# HISTORIC AND DESIGN REVIEW COMMISSION

July 20, 2022

**HDRC CASE NO:** 2022-345  
**ADDRESS:** 305 LAVACA ST  
**LEGAL DESCRIPTION:** NCB 708 BLK 8 LOT 2  
**ZONING:** RM-4, H  
**CITY COUNCIL DIST.:** 1  
**DISTRICT:** Lavaca Historic District  
**APPLICANT:** Caroline Gado  
**OWNER:** Leslie Jones/1918 MLK DEVELOPMENT GROUP LLC  
**TYPE OF WORK:** New construction of two, 2-story duplex structures  
**APPLICATION RECEIVED:** June 13, 2022  
**60-DAY REVIEW:** Not applicable due to City Council Emergency Orders  
**CASE MANAGER:** Rachel Rettaliata

The applicant is requesting conceptual approval to construct two, 2-story duplex structures at 305 Lavaca.

DUPLEX 1 TOTAL FOOT  
PRINT: 1696 SF

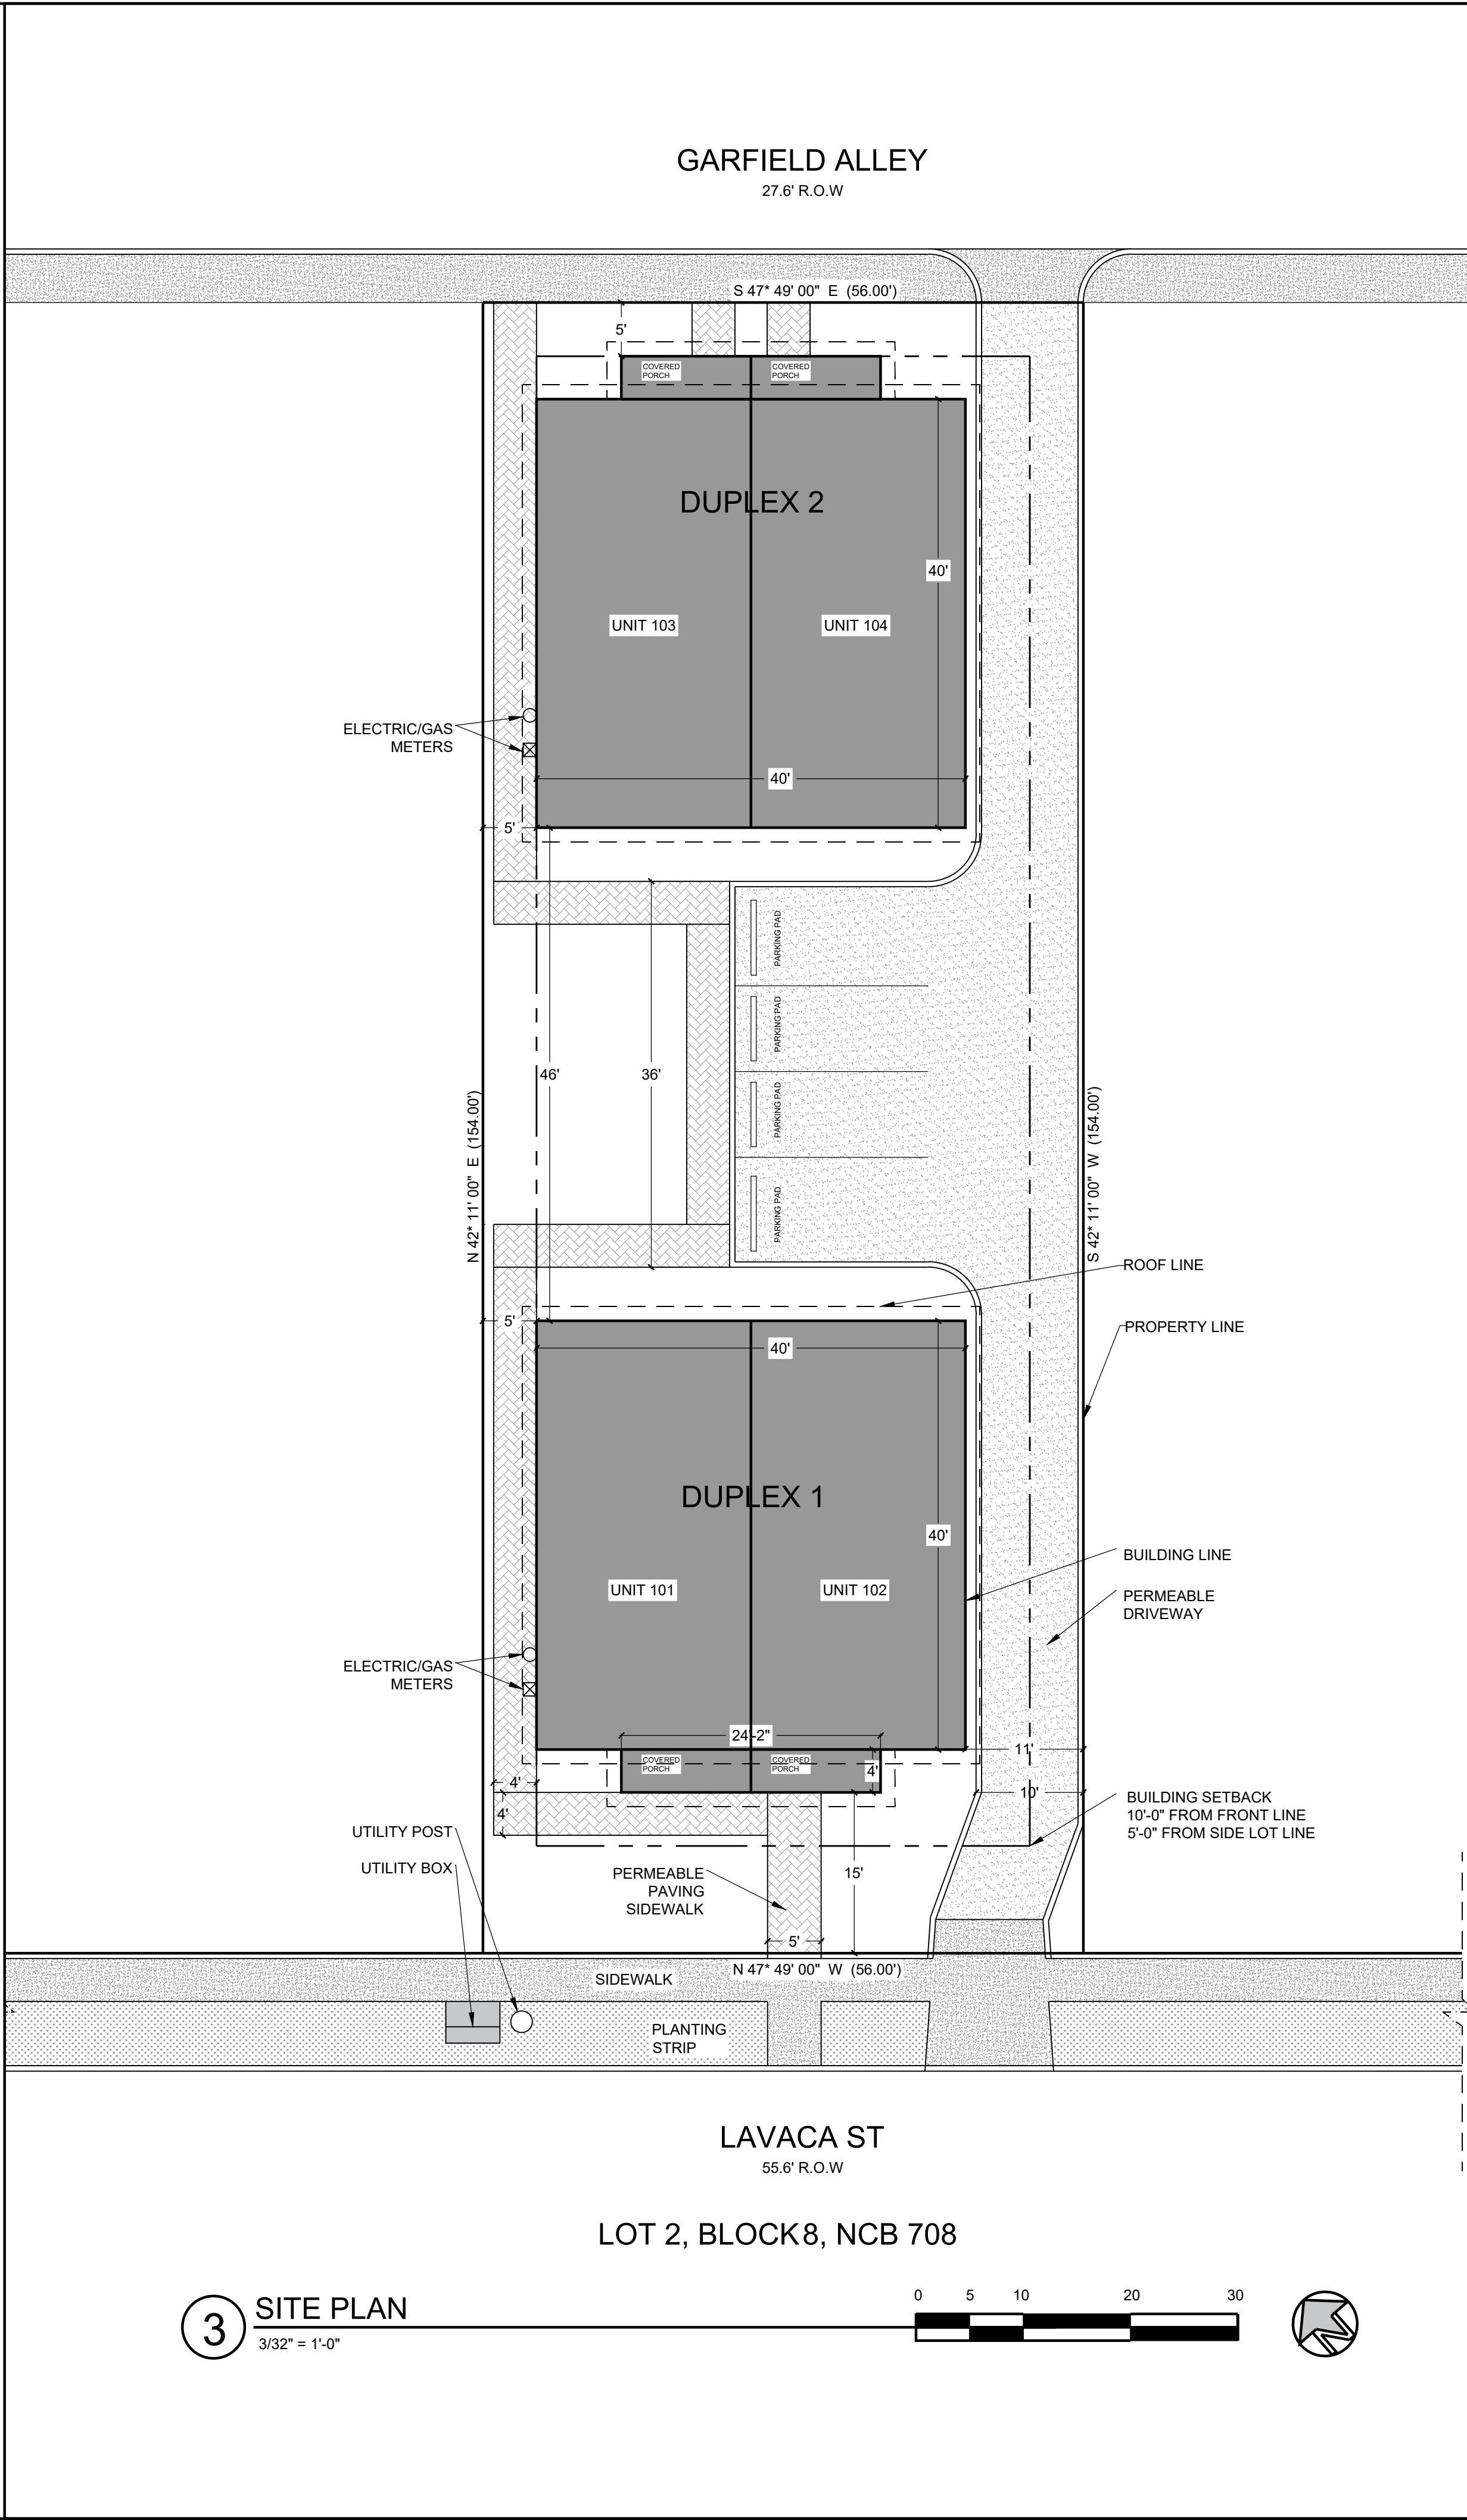
- d. SETBACK & ORIENTATION (LAVACA) – According to the Guidelines for New Construction, the front facades of new buildings should align with the front facades of adjacent buildings where a consistent setback has been established along the street frontage. Additionally, the orientation of new construction should be consistent with the historic examples found on the block. The applicant has proposed to construct two 2-story, duplexes residences at 305 Lavaca. The residences will be detached, with one duplex entrance facing Lavaca and the other duplex entrance facing Garfield Alley. The applicant has noted that the proposed setback from Lavaca will be 15 feet. The Historic Design Guidelines for New Construction stipulate that primary building entrances should be oriented towards the primary street and that front facades should be aligned with the front facades of adjacent buildings. Historically, homes have had frontage on both Lavaca and Garfield Alley. Staff finds that the applicant should provide a setback diagram noting the setbacks of neighboring structures.

- e. SETBACK & ORIENTATION (GARFIELD ALLEY) – According to the Guidelines for New Construction, the front facades of new buildings should align with the front facades of adjacent buildings where a consistent setback has been established along the street frontage. Additionally, the orientation of new construction should be consistent with the historic examples found on the block. The applicant has noted that the proposed setback from Garfield Alley will be 5 feet. Staff finds that the applicant should provide a setback diagram noting the setbacks of neighboring structures.

- p. **DRIVEWAYS** – Guideline 5.B.i for Site Elements notes that new driveways should be similar to those found historically within the district in regard to their materials, width, and design. Additionally, the Guidelines note that driveways should not exceed ten (10) feet in width. The applicant has proposed to install a 10-foot-wide permeable driveway on the east property line, extending the full length of the property from Lavaca to Garfield Alley with a central parking pad with four (4) parking spaces. Staff finds the proposal generally appropriate and

LG: Can you discuss the site plan a bit further? Will there not be parking or a thru-drive.

CG: We will now propose driveways for each unit on the sides of each duplex. Patio doors for each duplex will lead to the pool area.

RM: It looks like there is not enough room for 2 driveways.

RM: With the potential pool, where will the parking be.

- i. That the applicant provides a setback diagram showing that the proposed structure will not be located in front of the front façade wall planes of adjacent historic structures based on findings d and e.

- v. That the applicant incorporates front porch elements that are in keeping with the historic structures on the block based on finding o.
- vi. That the applicant submits material specifications for the permeable surfacing to staff for review and approval prior to returning to the HDRC for final approval based on finding p.

**③ REAR ELEVATION- NORTH**  
SCALE: 1/4" = 1'-0"

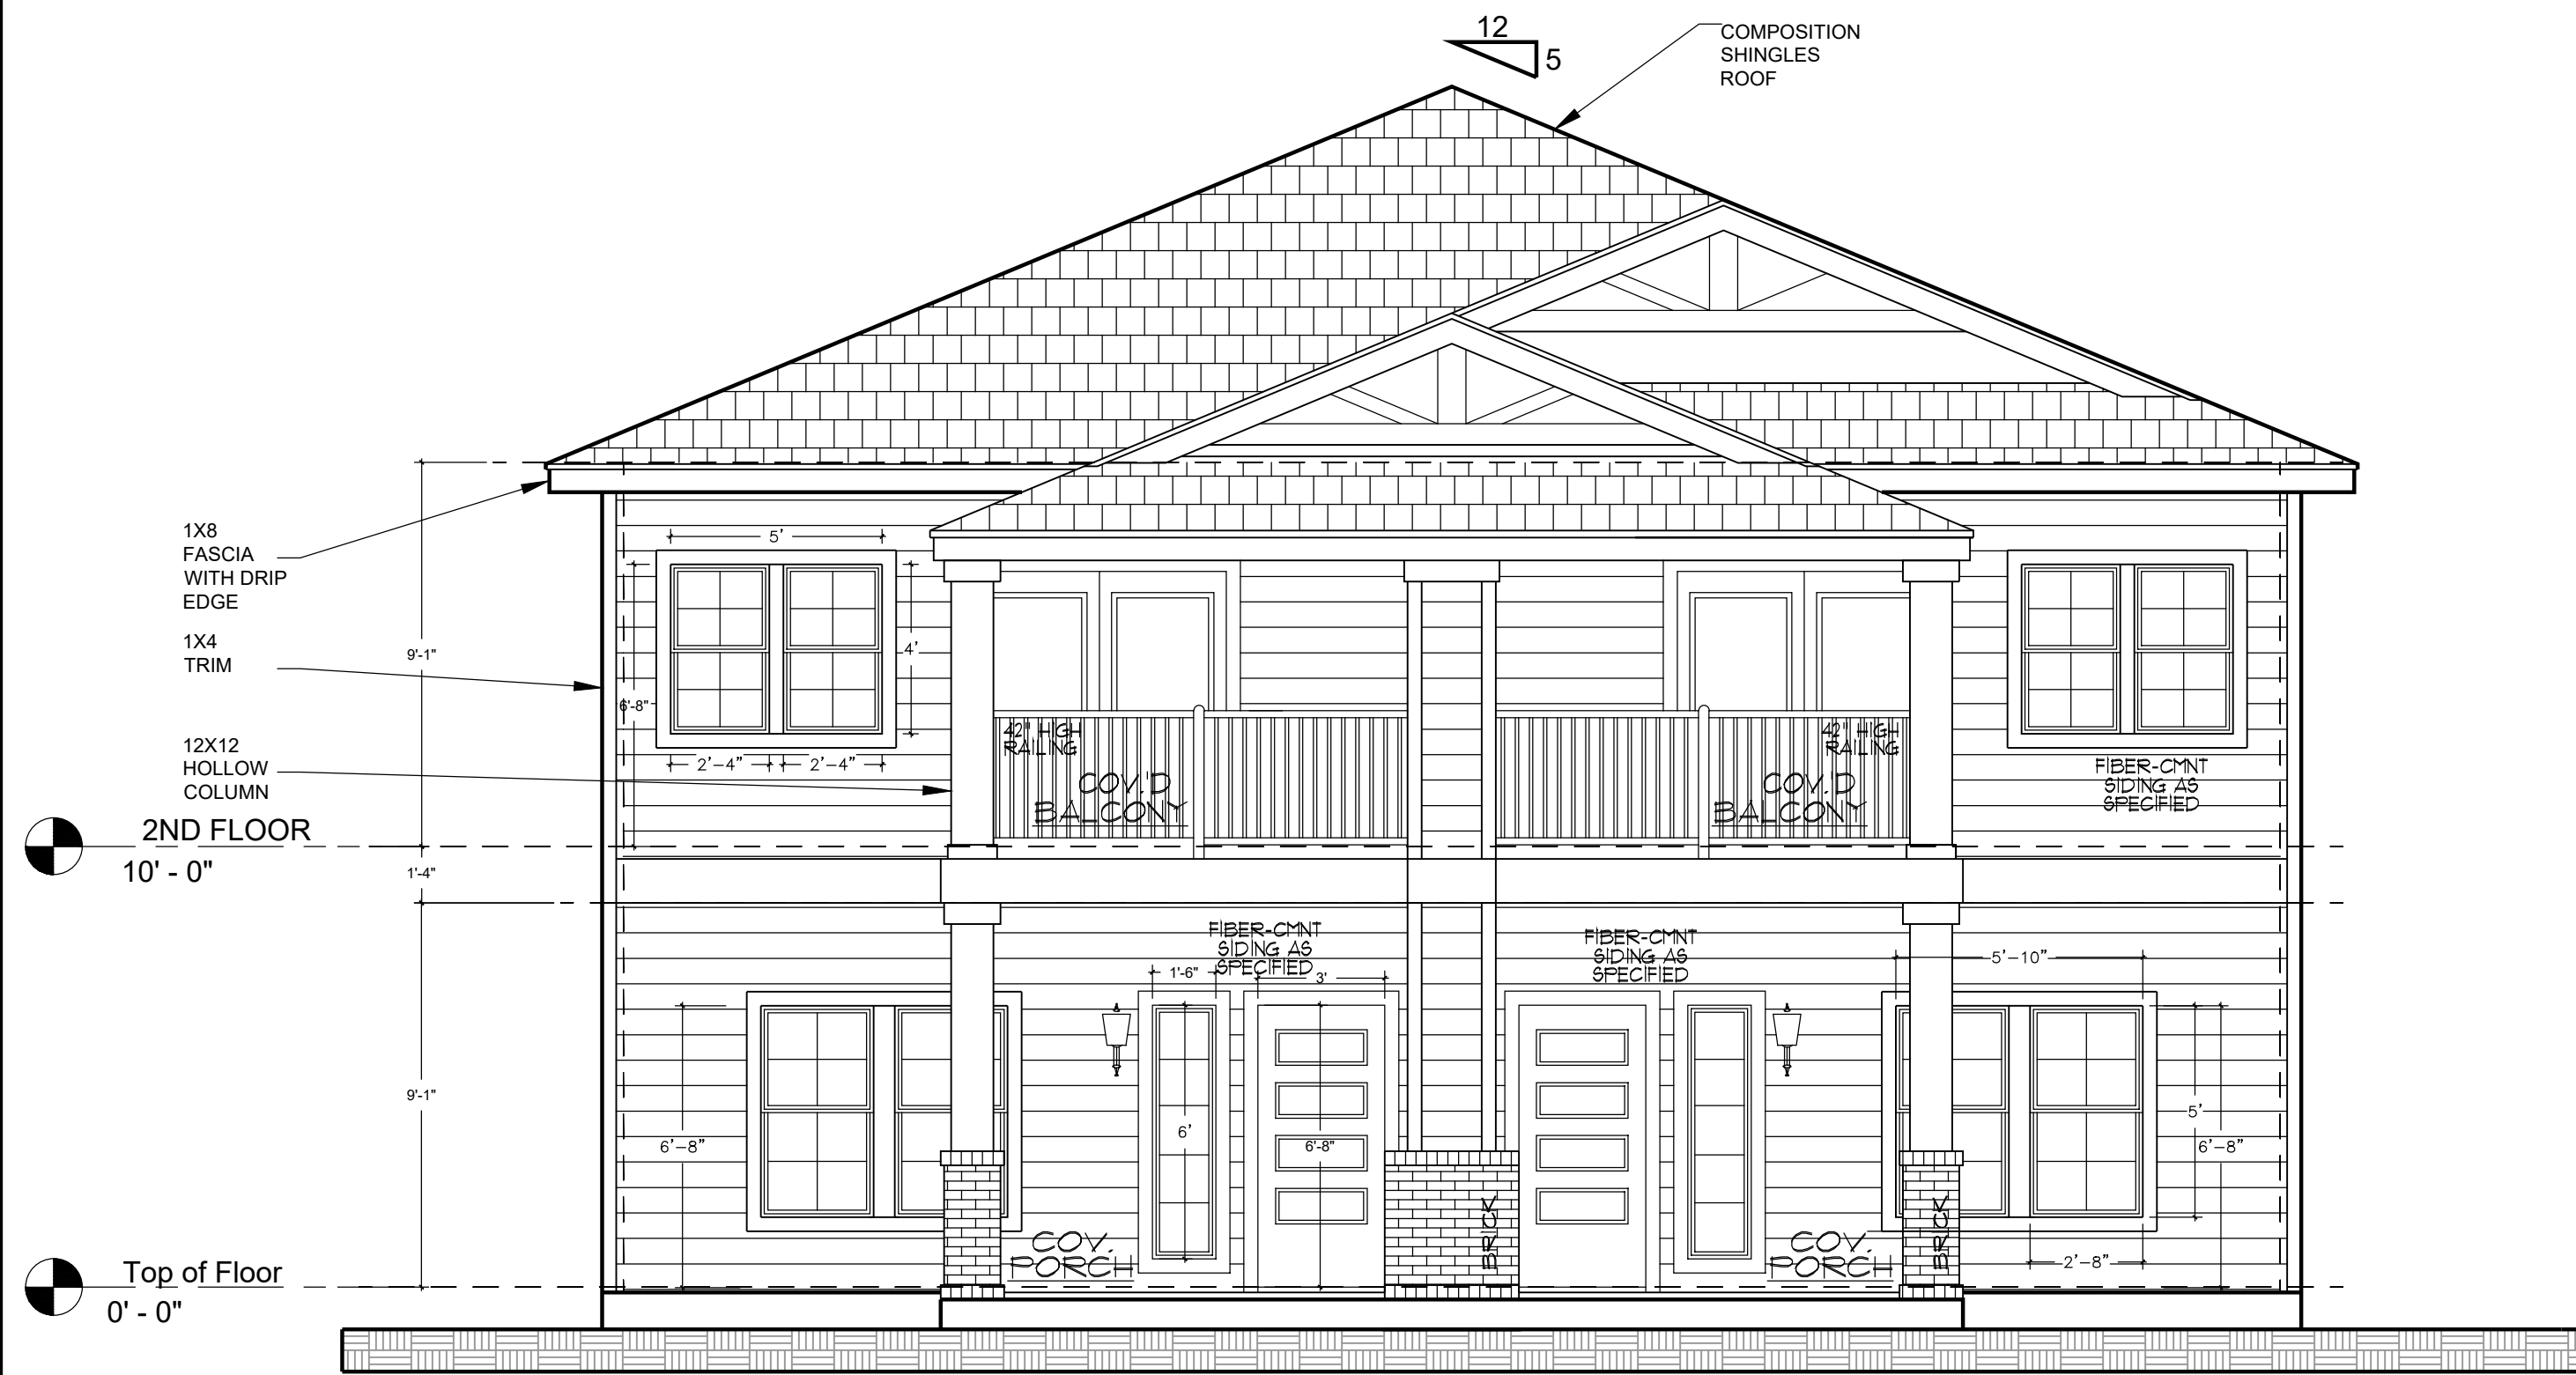
- m. **RELATIONSHIP OF SOLIDS TO VOIDS** – The applicant has proposed to install divided lite one-over-one windows on the duplex structures. The proposed fenestration pattern consists of sets of 2 ganged windows on the front facades, single, ganged, and small fixed windows on the side elevations, and single windows on the rear elevation. The proposed window proportions vary in size and all of the proposed windows do not appear to be in keeping with those historically found in the district. Guideline 2.C.i for New Construction states that window and door openings should be incorporated into new construction with a similar proportion of wall to window space as typical with nearby historic facades. Windows, doors, porches, entryways, dormers, bays, and pediments shall be considered similar if they are no larger than 25% in size and vary no more than 10% in height-to-width ratio from adjacent historic facades. Staff finds that the proposed fenestration should be updated to be more in keeping with the Guidelines.

LG: As far as massing and window and roof shape, this seems to comply looking at the elevations. There is an unusual window orientation, looking at the rear elevation.

- iv. That the applicant proposes window sizes, patterns, proportions, and trim and sill detailing that are consistent with the Guidelines and historic precedents in the district as noted in finding m.
